REGISTRATION INTERFACE
SERIES SINGLE LINE
TIP AND RING ARRANGEMENTS
RJ31X, RJ32X, RJ33X, RJ34X, RJ35X AND RJ36X

1.001 This addendum supplements Section 463-400-130, Issue A. Place this pink sheet ahead of page 1 of the section.

1.002 This addendum is issued to provide a new schematic of the 635A connecting block to agree with the production model.

Fig. 7—New Schematic of 635A Connecting Block

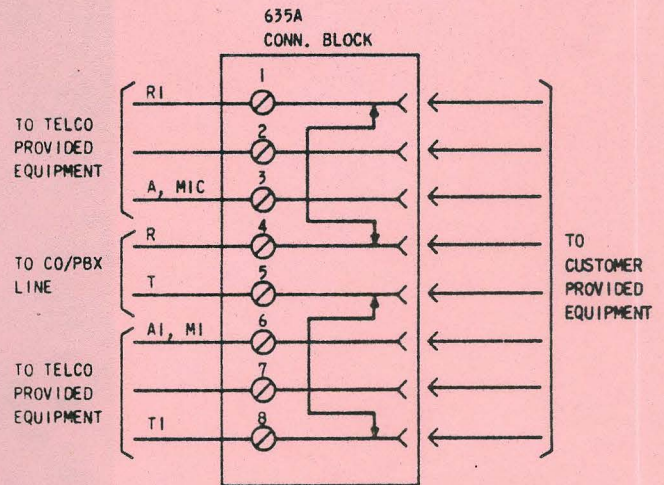
2.001 On page 1, revise paragraph 1.05 to read as follows; retain Note.

2.002 Add Fig. 7.

1.05 In the 635A connecting block, all eight terminals are wired to contact springs as shown in Fig. 7. A matching 8-contact plug must be used on the CPE to assure proper *series* circuit functions through the connecting block when the CPE is connected. All unused leads and terminals are reserved for telephone company use. Disposition of spare leads should be per local instructions.
